1 SITE PLAN - PARTIAL
SCALE: 1" = 20'-0"

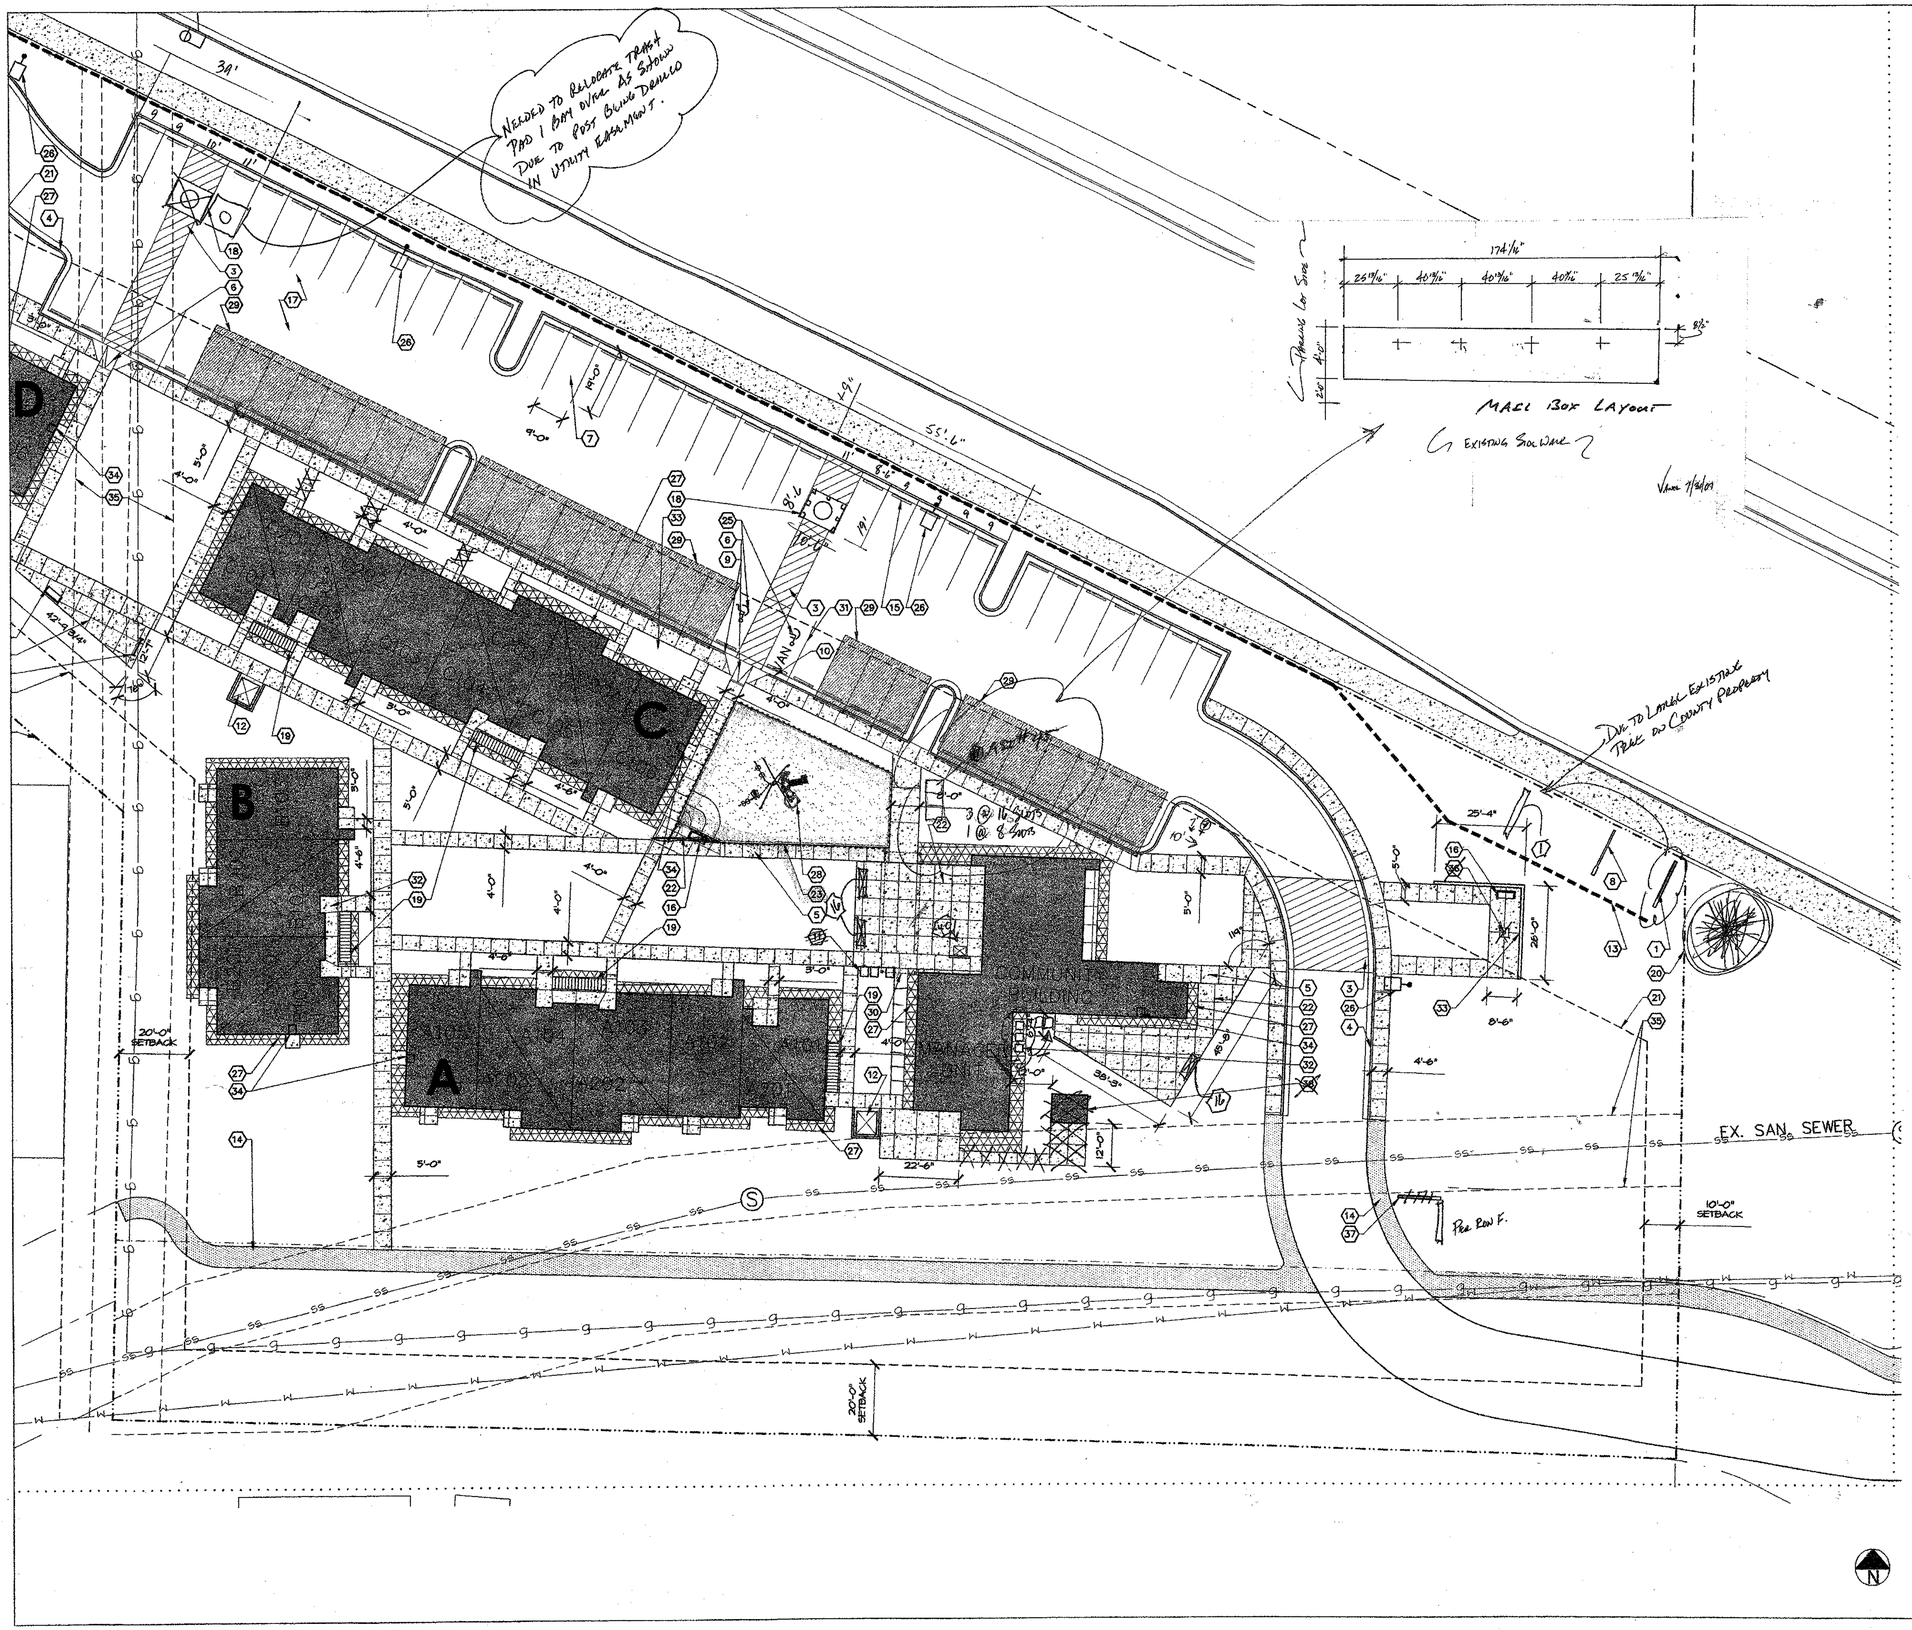
10. VAN HANDICAP SIGN & POST; SEE SHEET SP.3 DTL. 15
11. POSTAL PAD W/ POSTAL PEDESTAL - SEE ASI #5
12. TRANSFORMER & CONCRETE PAD BY E.C.; VERIFY SIZE; ~~PROVIDE SCREEN SIMILAR TO SHEET SP.3 DTL. 9,10,13~~

16. BENCH ON CONCRETE PAD (TYP.) (NEW LOCATION PER LISO DIRECTION 7/25)
17. ASPHALT; RE: CIVIL (TYP.)
18. TRASH ENCLOSURE LOCATED ON CONCRETE PAD; RE: CIVIL FOR PAD; SEE SHEET SP.3 DTL. 9,10,13

31. WHITE PARKING SPACE STRIPING
32. CONDENSER UNIT W/ CONCRETE PAD; RE: MECH. (TYP.)
33. ~~LANDSCAPE WALL (TYP.); SEE SHEET SP.3 DTL. 6~~
34. FIRE SPRINKLER SYSTEM ACCESS (TYP.)

35. EASEMENT RE: CIVIL
36. ~~FLAG POLE AND BASE ON CONCRETE PAD; ADD ALTERNATE~~
37. PROJECT LOCATOR SIGN; SEE SHEET SP.3 DT. 4 & 5
38. ~~GROUNDS EQUIPMENT STORAGE; SEE SHEET GB02 DTL. 15,6,7,8~~

1 5 PLEX (M1) - FIRST FLOOR - BLDG. B,E,F, + G
SCALE: 1/8" = 1'-0"

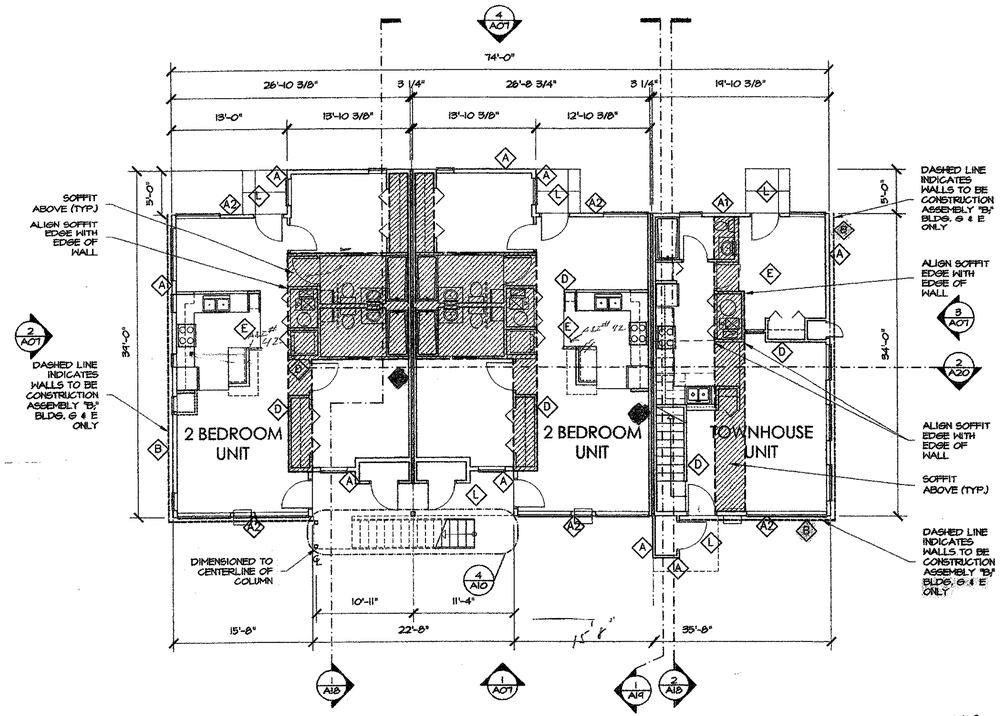
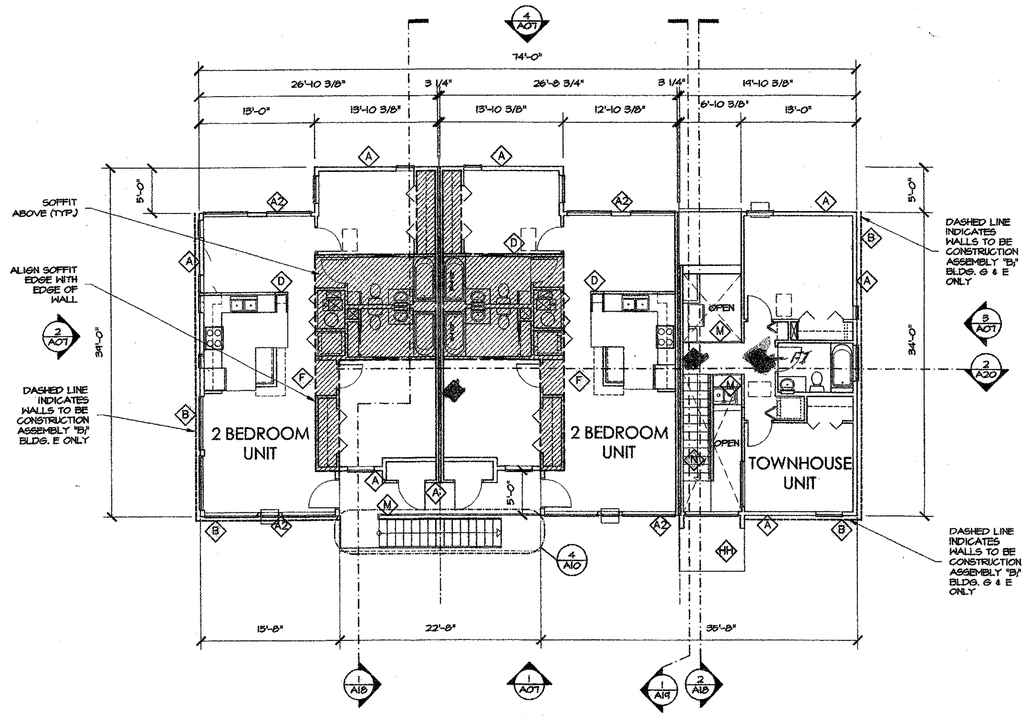
Sheet A01 of 37 – 5 Plex (M1) – First Floor – Bldg. G: The two bedroom unit in the middle of building 'G' corresponds with the 'Fully Accessible 2 Bedroom Unit' shown on Sheet A17 of 37.

1 M1 MAIN FLOOR PLAN
SCALE: 1/4" = 1'-0"

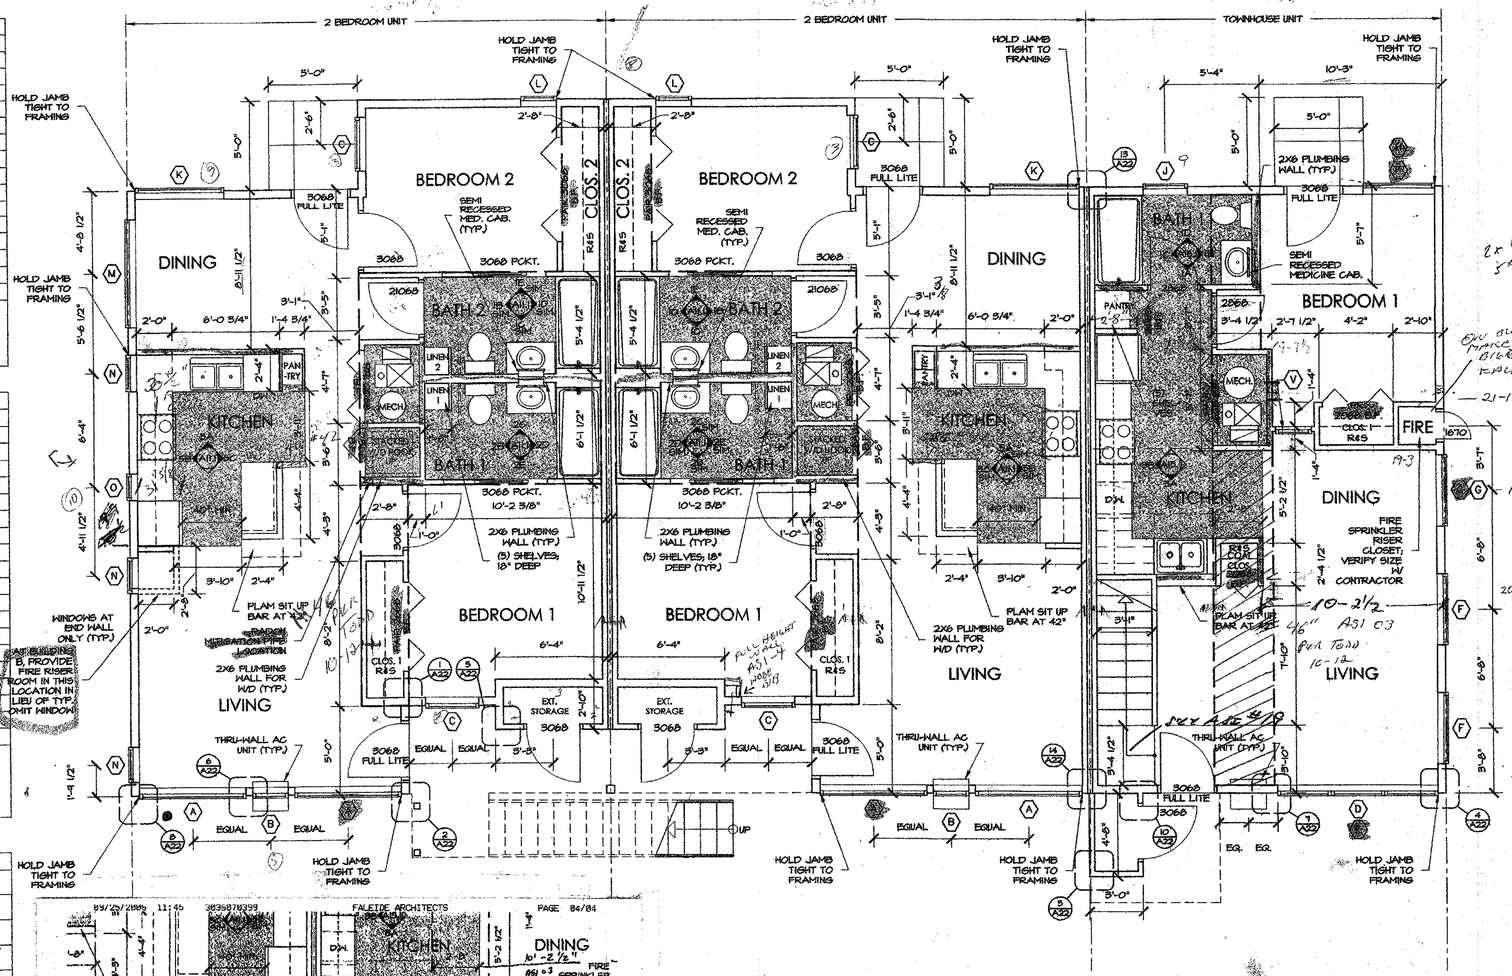
1 – Sheet A11 of 37 – M1 Main Floor Plan: The kitchen plan in the two bedroom refers to Sheet A11.1 Elevation 5A.

2 – Sheet A11.1 of 37 – Interior Elevation 5A: Provide door to pantry as shown on elevation. Contractor's option to provide hollow core door or casework door.

1 FULLY ACCESSIBLE 2 BEDROOM UNIT
SCALE: 1/4" = 1'-0"

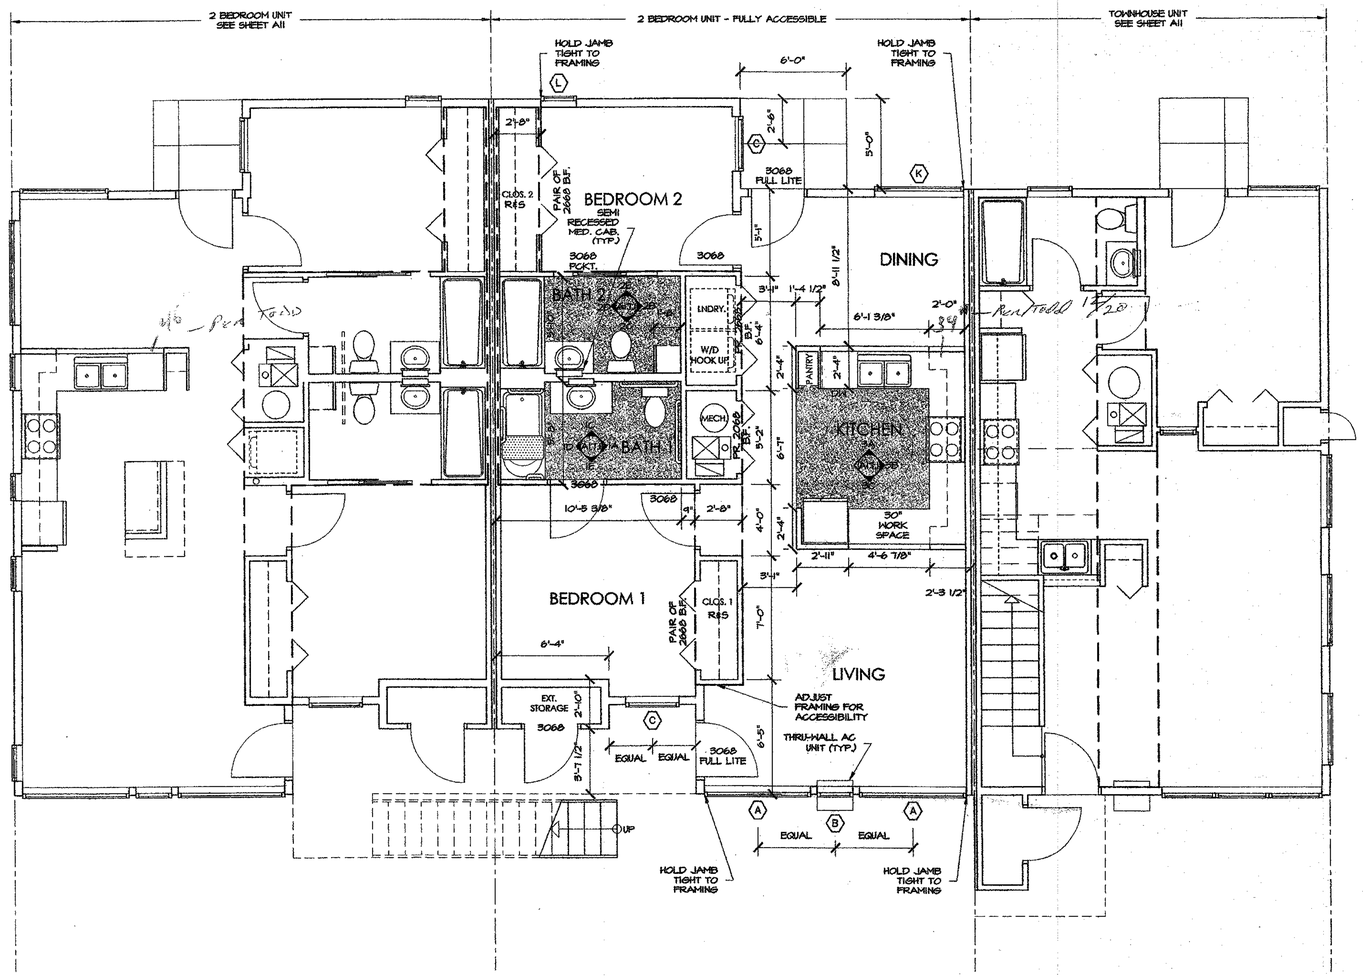
1 – Sheet A11 of 37 – M1 Main Floor Plan: The kitchen plan in the two bedroom refers to Sheet A11.1 Elevation 5A.

3 – Sheet A17 of 37 – Fully Accessible 2 Bedroom Unit: The kitchen plan in the two bedroom accessible unit refers to Sheet A17.1 Elevation 3A.

4 – Sheet A17.1 of 37 – Interior Elevation 3A: Provide door to pantry as shown on elevation. Contractor's option to provide hollow core door or casework door.

1 MAIN FLOOR PLAN OF COMMUNITY BUILDING + MANAGERS UNIT
1671 SF (COMMUNITY BLDG.) + 983 (MANAGER'S UNIT) = 2,654 SF
SCALE: 1/4" = 1'-0"

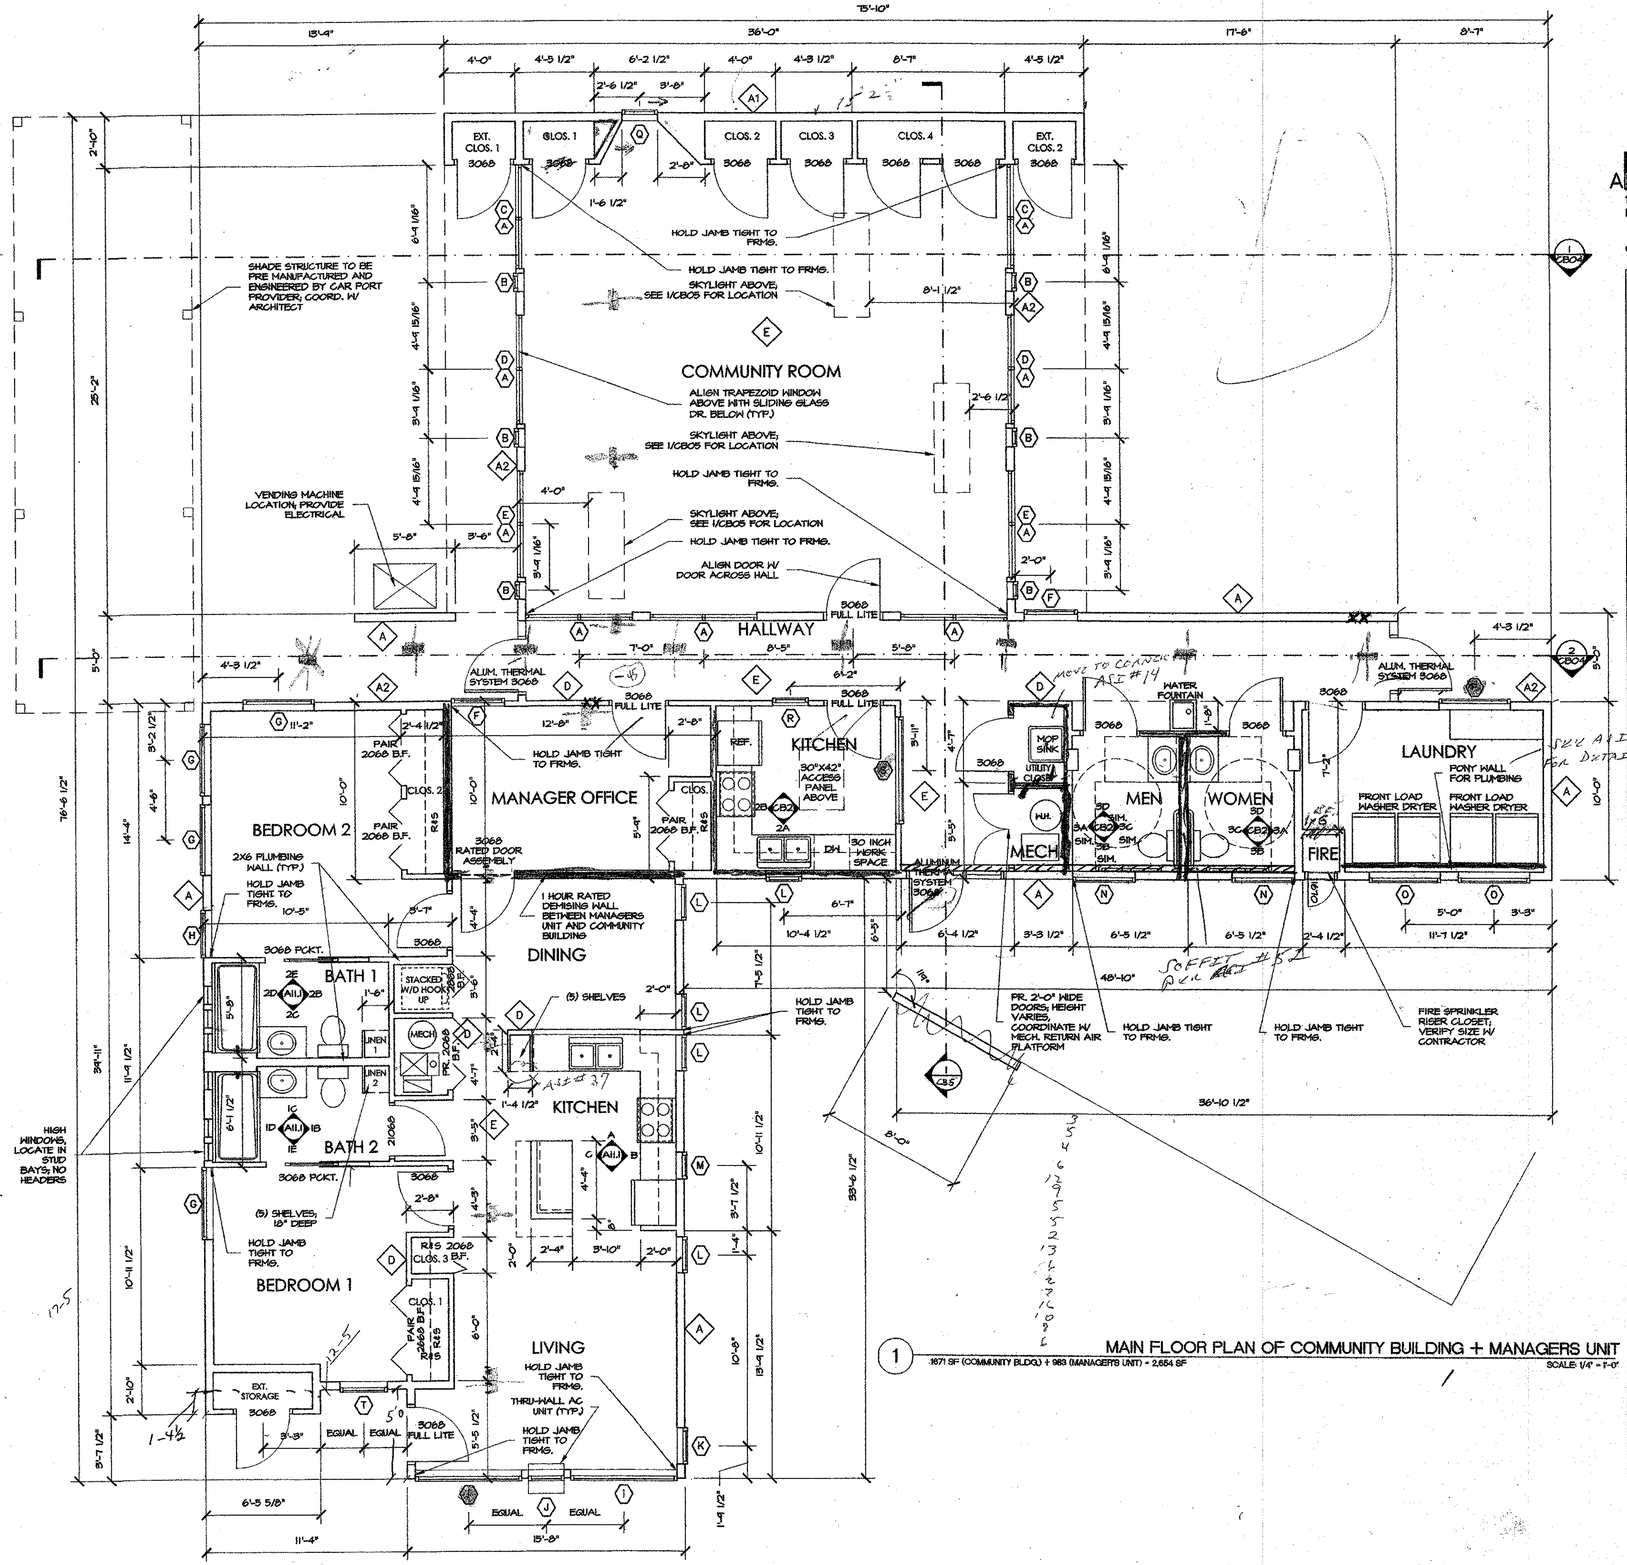
Sheet CB01 of 37 – Plan 1 – Windows C, D and E: In lieu of the dimensions shown on the window schedule, use the updated dimensions shown on attached Sheet 01, Sheet 02, Sheet 03, and Sheet 04.

Sheet CB01 of 37 – Plan 1 – Laundry Pony Wall: See attached Sheet 05 for height of wall and wall cap detail.

Sheet CB01 of 37 – Community Building – Utility Room: Place the mop sink tight to the SE corner of the room. The attached Sheet 01. Plumbing for the mop sink is to come through the north wall to avoid the paper towel receptacle/dispenser in the adjacent bathroom. Provide Fiber Reinforced Plastic (FRP) on the wall at the east and south edges of the mop sink. The FRP is to extend vertically up the wall 4 feet from finish floor and extend horizontally to the edges of the mop sink. Coordinate plumbing locations with PT slab.

Sheet CB01 of 37 – Community Building – Mechanical Room: See attached Sheet 02 for section through mechanical room and mechanical return air platform.

1 COMMUNITY BUILDING - ROOF PLAN
SCALE: 1/8" = 1'-0"

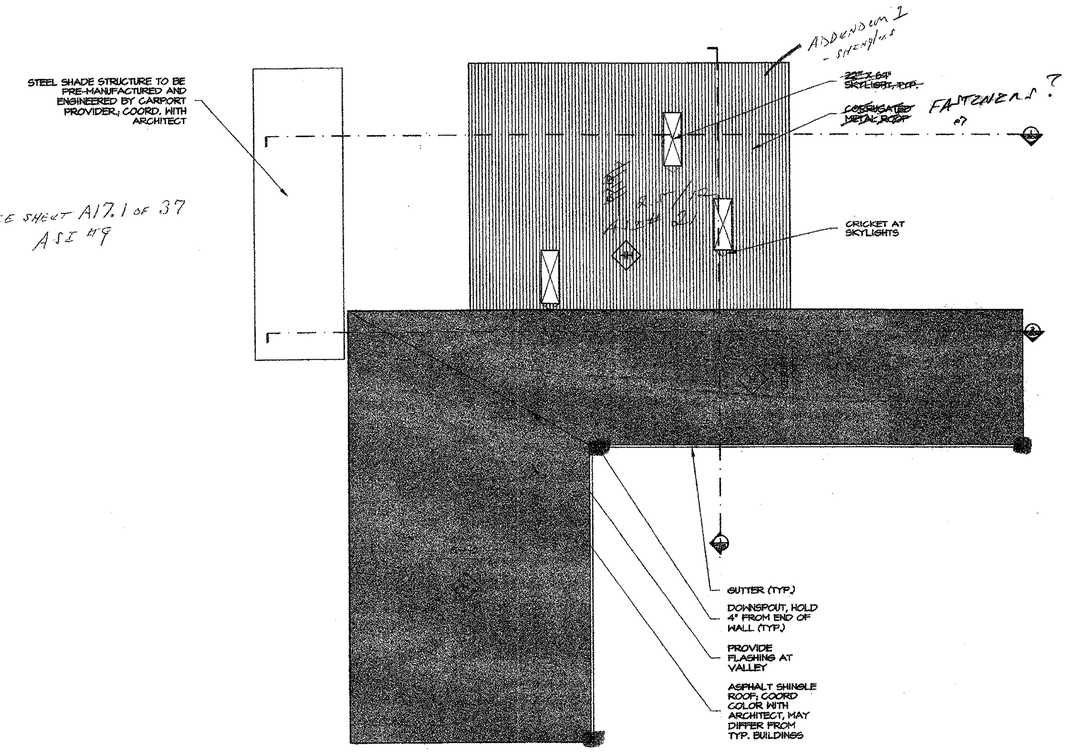
Sheet CB02 of 37 – Plan 1: The roof pitch of the Community Room is to match Section CC's pitch of 2.5/12 in lieu of the roof pitch shown.
